**HISTORIC LANDMARK COMMISSION**  
**PERMITS IN NATIONAL REGISTER HISTORIC DISTRICTS**  
**APRIL 5, 2023**  
**HR-2023-027364**  
**TRAVIS HEIGHTS-FAIRVIEW PARK NATIONAL REGISTER HISTORIC DISTRICT**  
**1611 DRAKE AVENUE**

Construct a new residence.

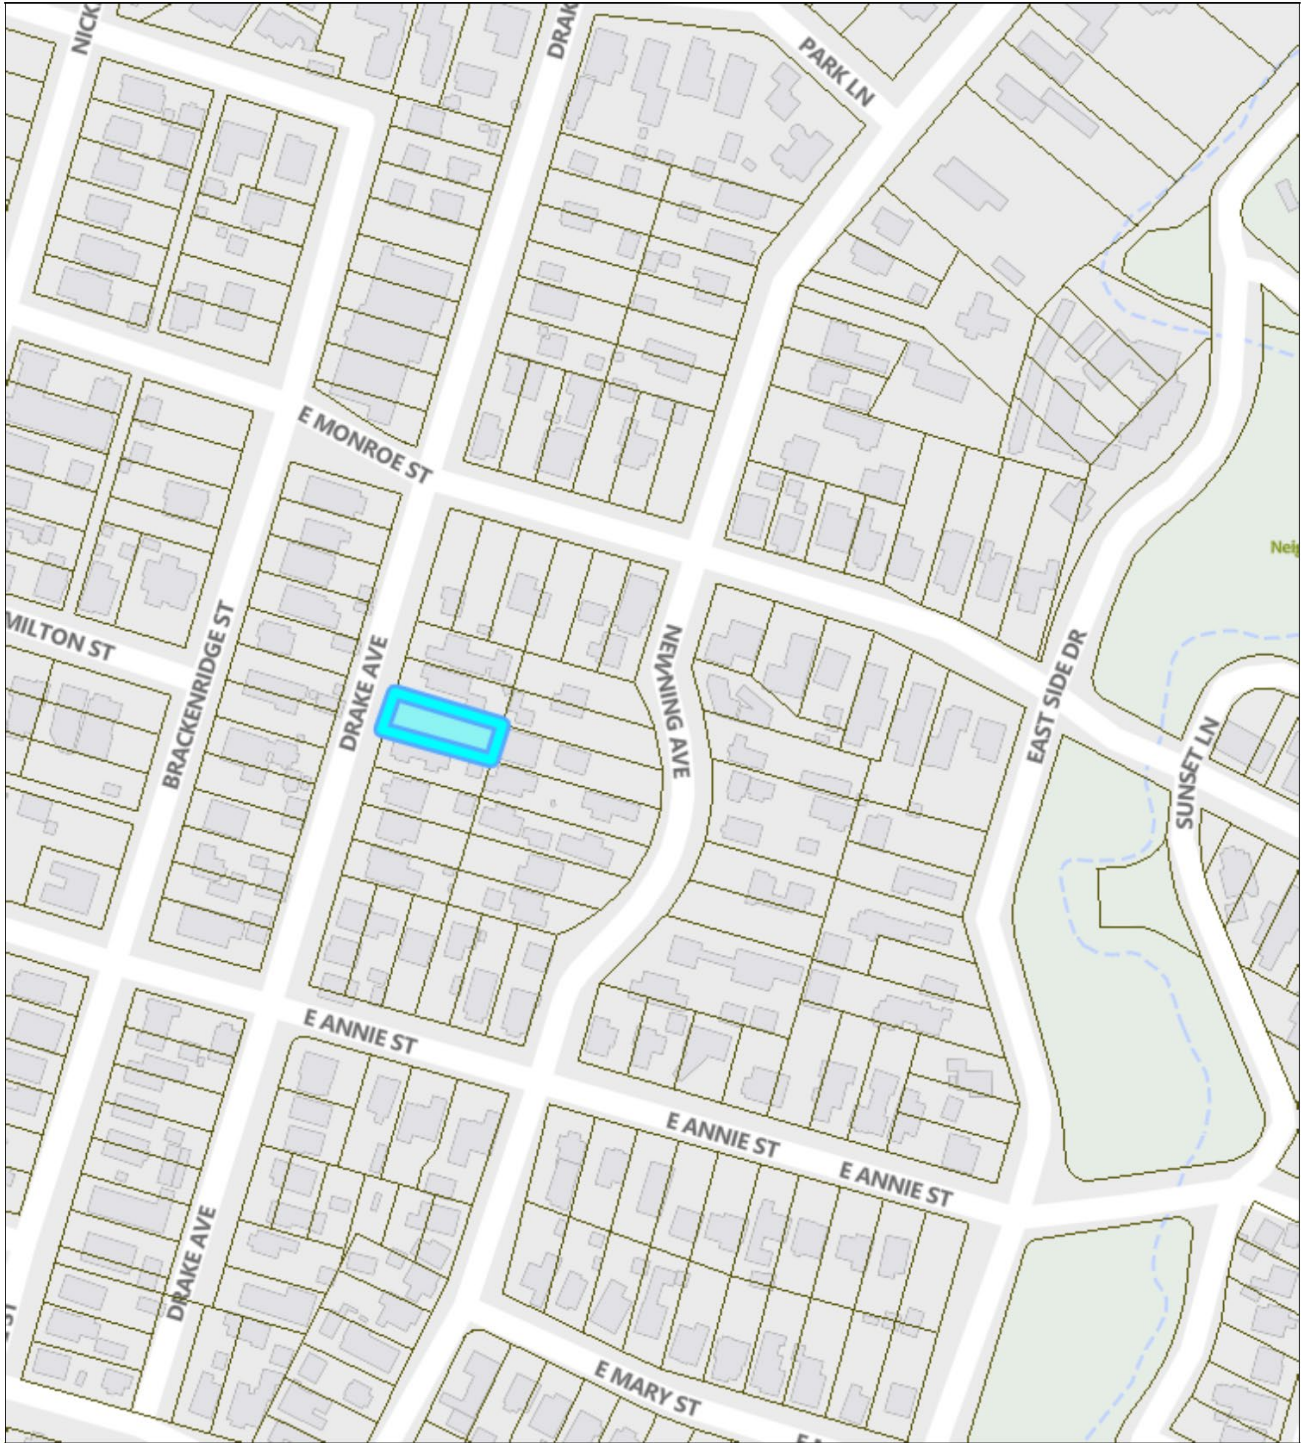
The proposed new building is taller than nearby contributing buildings, which are one story. Its compound massing is not compatible with the simple forms of the contributing buildings.

While the design's multiple step-downs help to provide visual transitions, the multiple gables emphasize the building's verticality. Its proportions are not consistent with nearby contributing buildings'.

The complex roof form is not compatible.

The proposed irregular, undivided fenestration is not compatible with nearby contributing buildings.

The proposed porch does not reflect the size, proportions, placement, depth, and rhythm of porches on contributing buildings within the district

The proposed front-facing garage is not compatible.

The project does not meet most of the applicable standards.

Comment on plans.
